Model: Dolphin		Date: 31-Jul-01	No.: MB010001
Modified Article: Parts Catalog		Prepared by: F. Noguchi	
From: Technical Services Dept., GTS Division			
Reason for Modification:	☒ Parts catalog correction ☐ To facilitate assembly ☐ Part standardization	☐ Vendor change ☐ To improve reliability ☐ Other	☐ To meet standards ()

Please correct your Parts Catalogs as follows:

Page 89 31. Frame Section 2

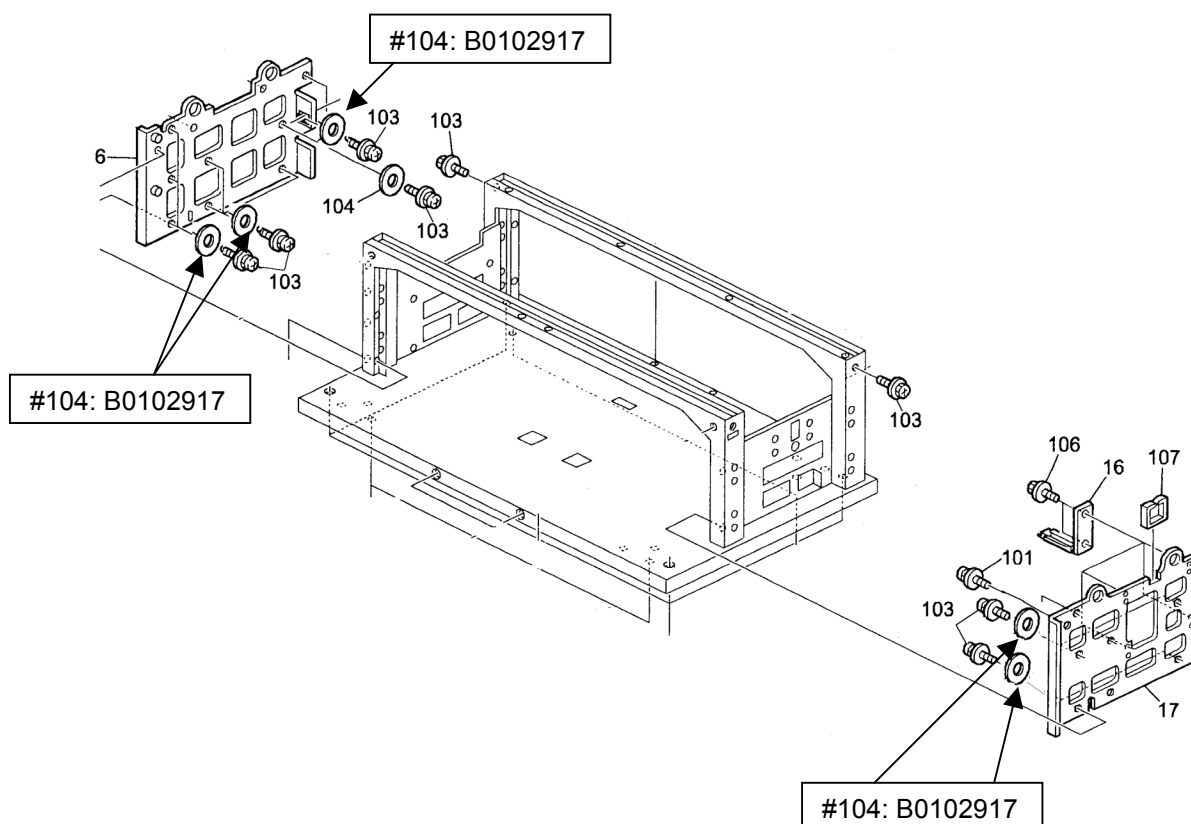
2. Three index callouts for the same part (Spacer, #104) have been added to the illustration on pg. 89:

Part number	Description	Q'ty	Page	Index	Note
Incorrect	07080050B	Washer – M5	n	89	104	
Correct	B0102917	Spacer – 5x12x2.3	16	89	104

10.CHARGE CORONA SECTION (B010)

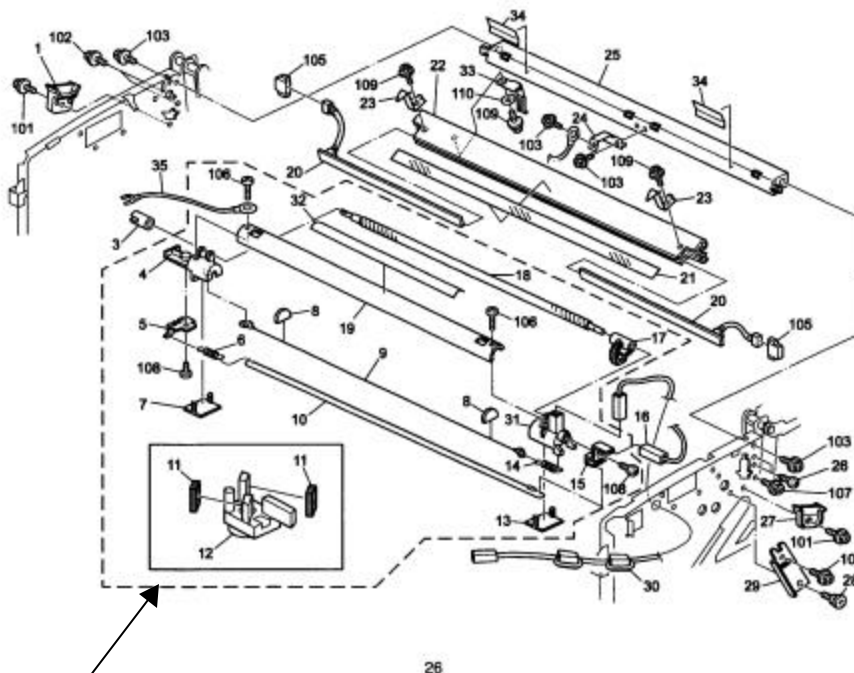
- Added index "2" to the illustration.
10. Charge Corona Section (pg. 26):

Index 2

Shield Plate
P/N B0101066

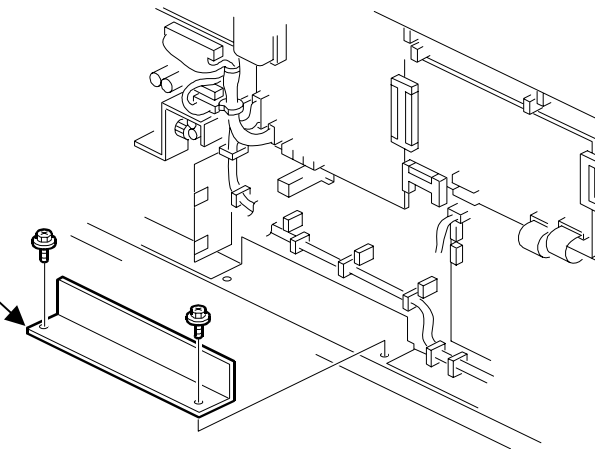
To further minimize the effect of electrical noise, a Shield Plate has been added in front of the HDD attachment area. Since this plate is not used when the HDD option is present, please remove it before the HDD option is installed.

Old part number	New part number	Description	Q'ty	Page	Index	Note
	B0101066	Shield Plate	0 - 1	65	*25	
04514008B		Phillips tapping Screw – M4x8	n - n+2	65	115

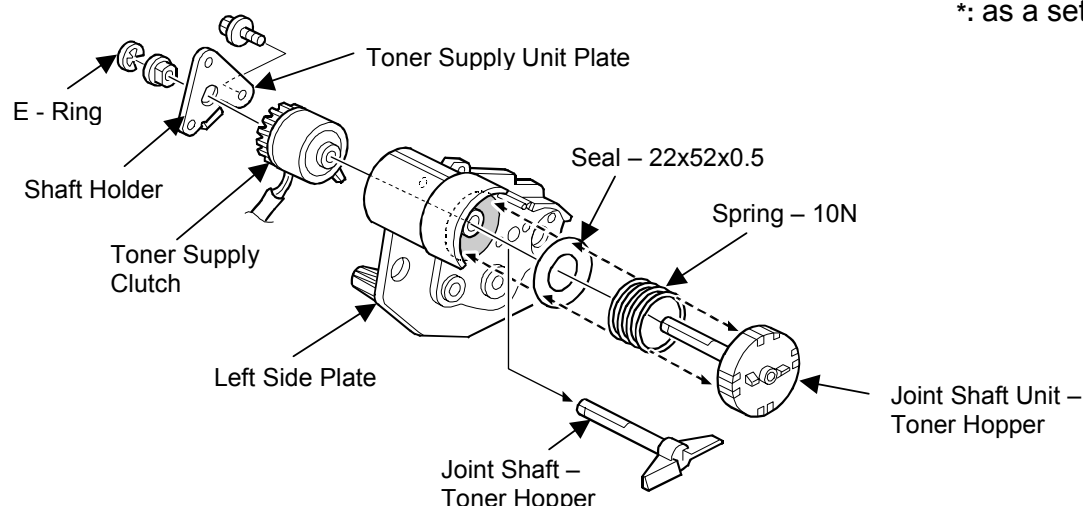
To ensure that the gear (AB017539) does not break when the toner cartridge is inserted in the toner hopper without being shaken, the Toner Hopper Joint Shaft has been changed as shown below.

1. Remove the Joint Shaft – Toner Hopper (1 e-ring, 1 screw).
2. Clean the left side plate with alcohol and then attach the Seal.
3. Attach the spring to the Toner Hopper Joint Shaft Unit and then insert the unit into the Left Side Plate as shown.
4. While pushing in the Joint Shaft Unit, reattach the Toner Supply Clutch, Toner Supply Unit Plate and Shaft Holder, then secure them with the e-ring.

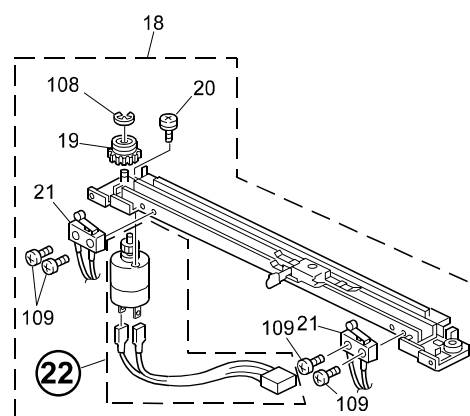
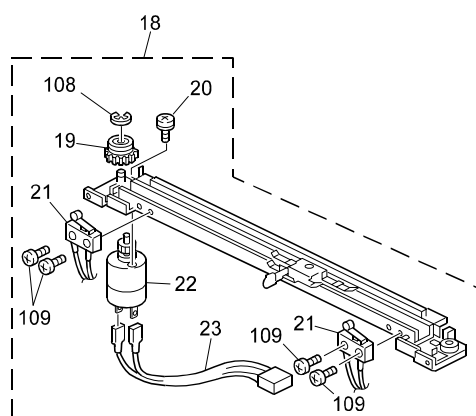
To facilitate servicing, the DC Motor service part has been changed to include the harness and gear.

Old part number	New part number	Description	Q'ty	Int	Page	Index	Note
AX050092		DC Motor – DC24V 7.18W	1 - 0	X/	33	22	
B0102836		Motor Harness	1 - 0	X/	33	23	
	B0102852	DC Motor: DC24V 7.18W	0 - 1	/O	33	22

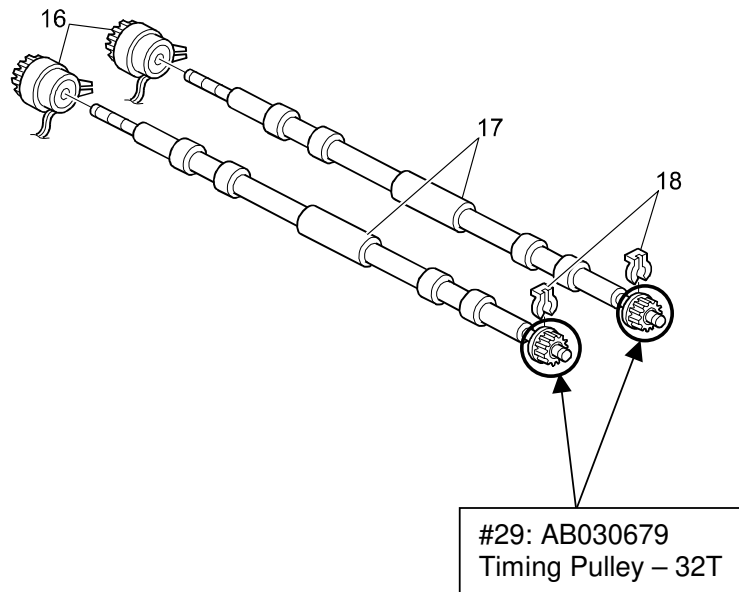
As per a field request, the following part has been registered as a service part.

New part number	Description	Q'ty	Page	Index	Note
AB030679	Timing Pulley – 32T	2	35	29

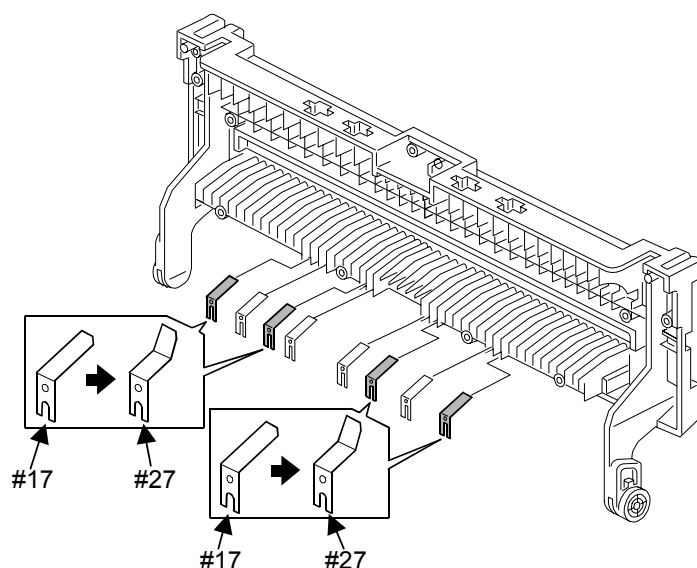
Change: Shape of the spring plate

Reason: To minimize waves in film that has a width of 420mm or less.

Old part number	New part number	Description	Q'ty	Int	Page	Index	Note
B0104454	B0104454	Lower Spring Plate – Exit Roller	8 - 4	X/O	59	17	*1
	B1884454	Spring Plate: Exit Roller: Lower	0 - 4		59	21	*2

31. FRAME SECTION 2 (pg. 68):

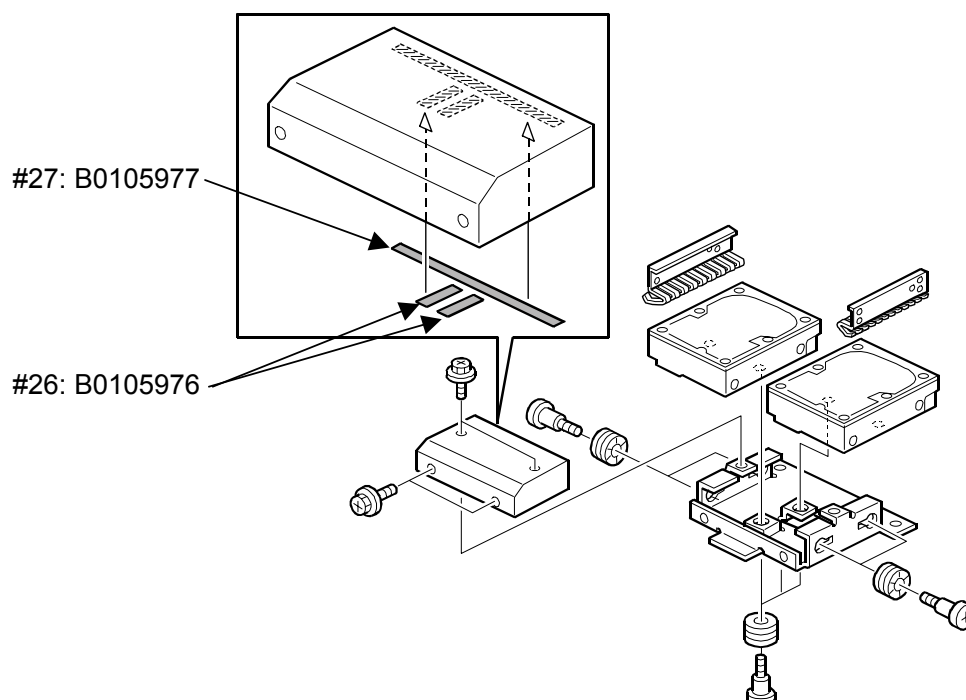
Change/Reason: These parts were missing from the Parts Catalogue.

New part number	Description	Q'ty	Page	Index	Note
B0105976	Gasket: HDD	2	69	26	
B0105977	Gasket: HDD: 180	1	69	27
